ENGINEERING CHANGE NOTICE

1. ECN 666067

6. Project Title/No./Work Order No.	7. Bldg./Sys./Fac. No.	8. Approval Designator	
		Interim Stabilization, Essential Drawings, 113340	241-G/200-GEN	N/A

RPP-7567, REPORT ON NEW PUMPING SYSTEM SOFTWARE ON PUMPING
INSTRUMENTATION AND CONTROL SKIDS

LAD 2 - --- Total Rungs in File = 19

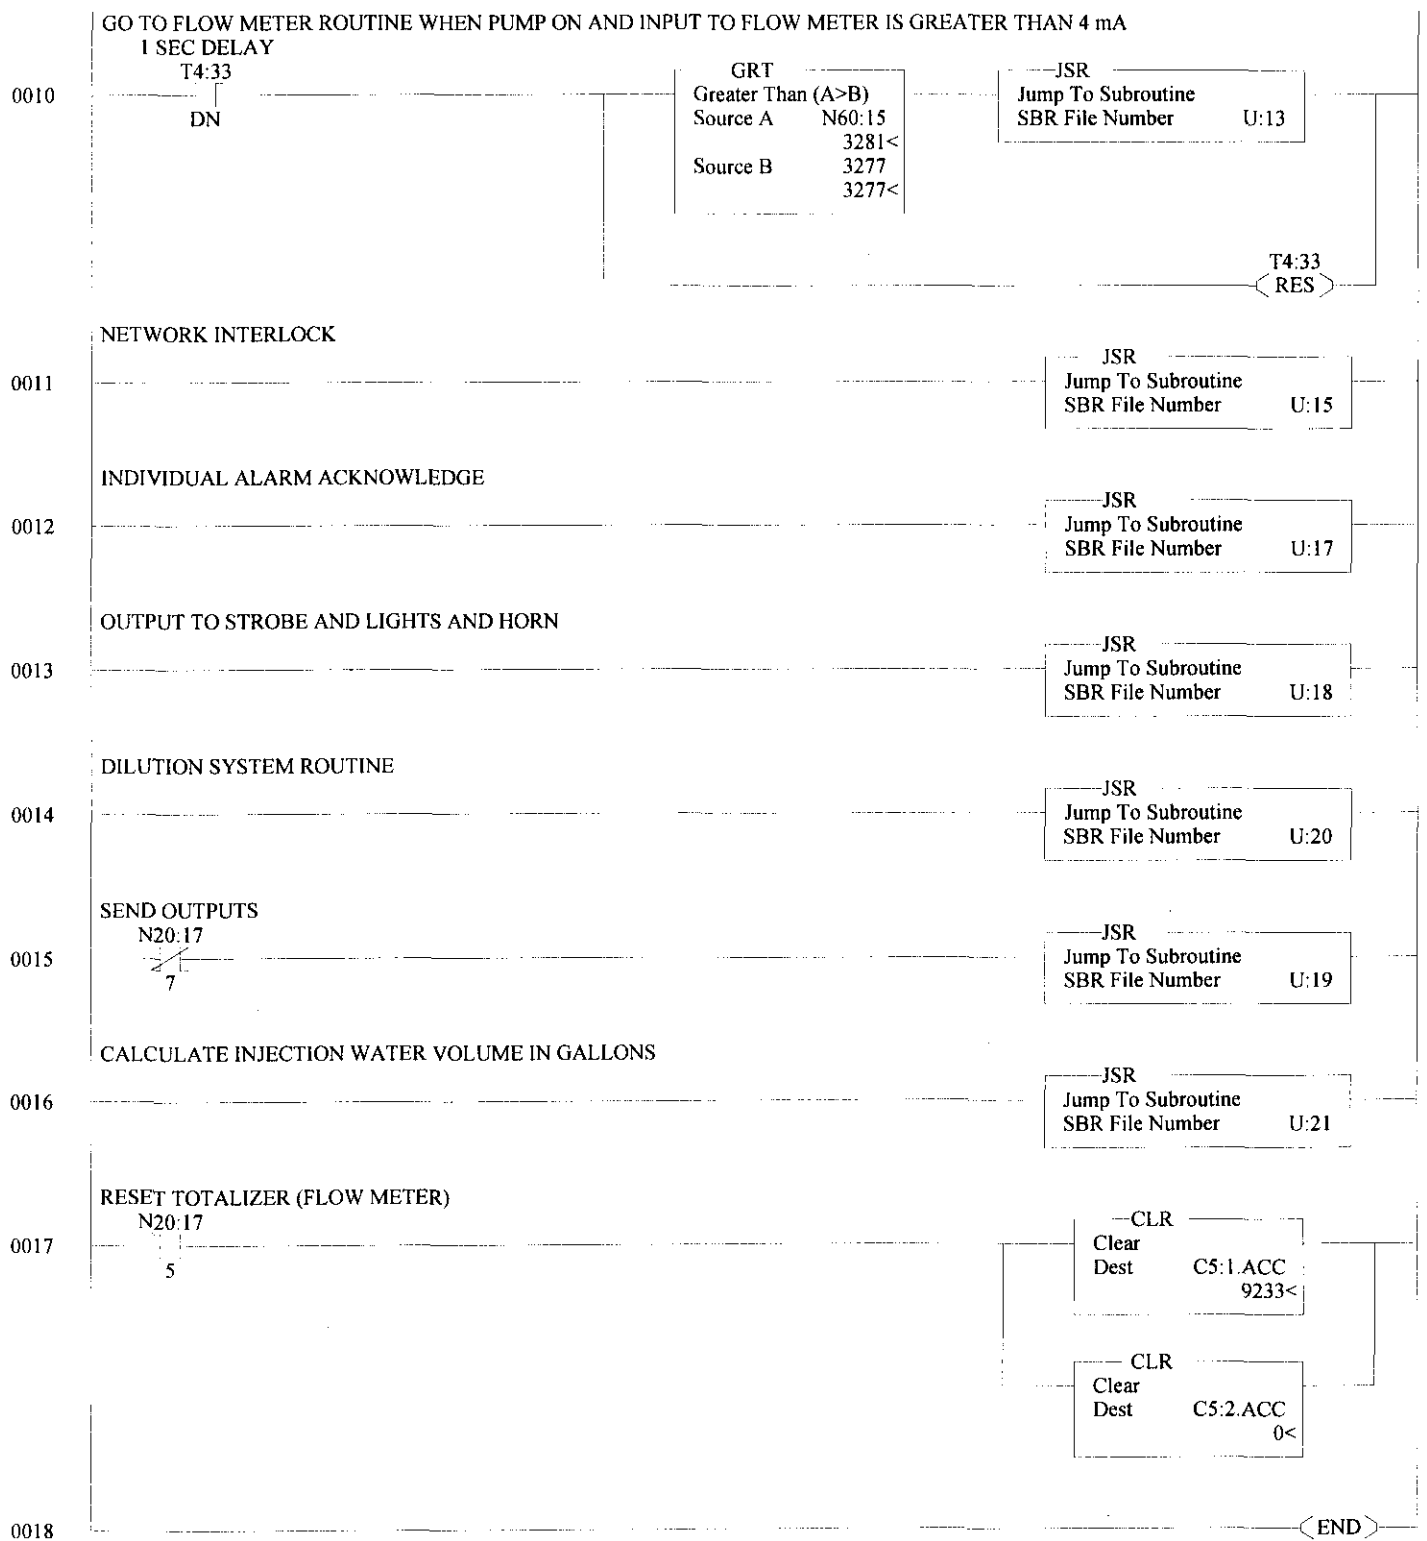
- 6.2 Ladder 2: A new subroutine 21 is added for the calculation of the injection water volume.
- 6.3 Ladder 3: This is the first pass subroutine used to set initial conditions in the remaining ladder logic. Three new rungs 6 through 8 are added to set initial conditions for the bump start logic in ladder 7. These settings are to ensure that a bump start will be set for the first time the PLC is turned ON. One new rung 9 is added to ensure the volume in subroutine 21 does not reset unexpectedly.

LAD 4 - --- Total Rungs in File = 11

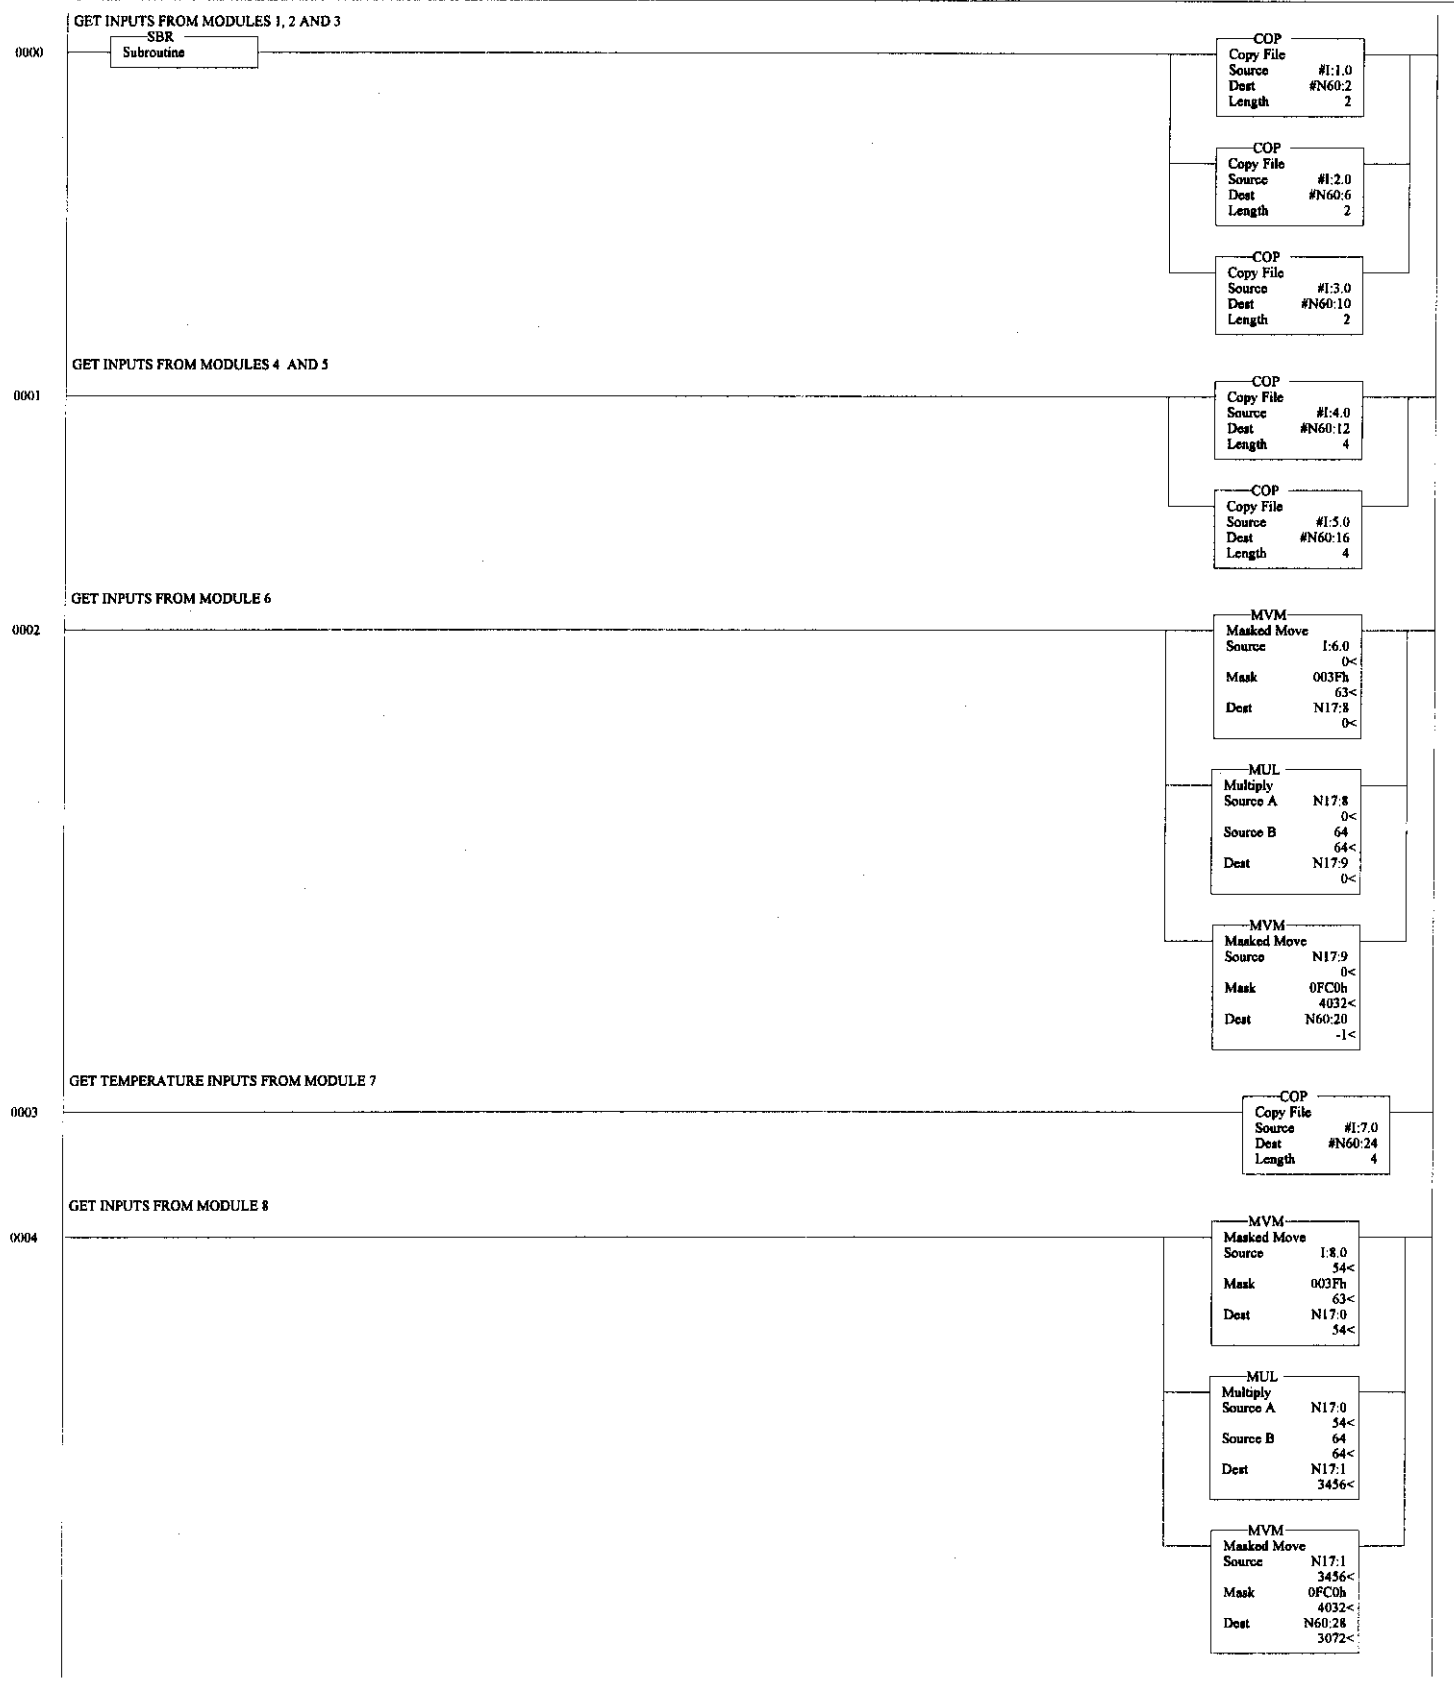
- 6.4 Ladder 4: Rung 1 is changed to remove data module 6. New rung 2 is added for data module 6 since it is changed from an analog to a relay data module.
